# Access Compliance Report

## Public Rights-of-Way

### (Island Curb Cuts)

| Intersection ID: 17513                  | Main Street: PROVIDENCE_DR   | Cross Street: PROVIDENCE_RD             | Location: SE           |

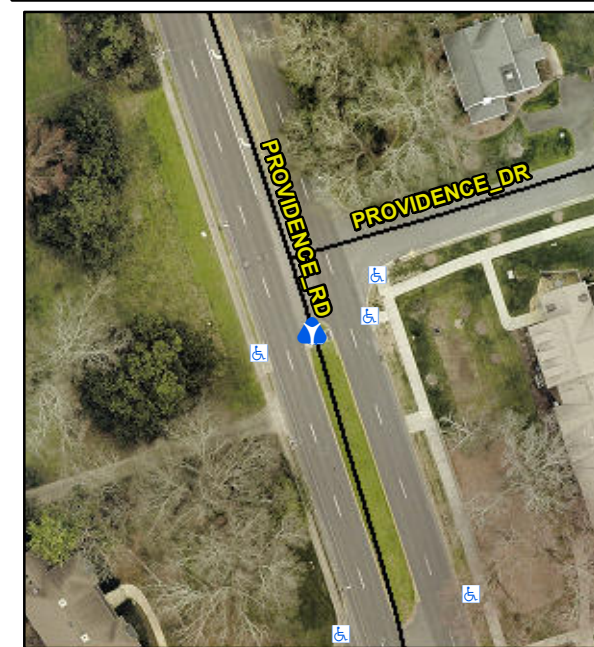
| ADA ID: 46AB6E241666                    | Curb Cut Type: MedianRefuge2 | Initial Pass/Fail: Fail                 | Overall Compliance: No |

| Compliance | Description          | Data  | Compliance | Description                 | Data |
|------------|----------------------|-------|------------|-----------------------------|------|
| No         | Refuge 1 Width (In)  | 59.0  | N/A        | Gutter 1 Lip Ht (In)        | N/A  |
| No         | Refuge 1 X Slope (%) | 5.2   | N/A        | Gutter 1 X Slope (%)        | N/A  |
| No         | Refuge 2 Width (In)  | 59.0  | N/A        | Gutter 2 Lip Ht (In)        | N/A  |
| No         | Refuge 2 X Slope (%) | 6.9   | N/A        | Gutter 2 X Slope (%)        | N/A  |

**Remove & Replace Entire Refuge.**
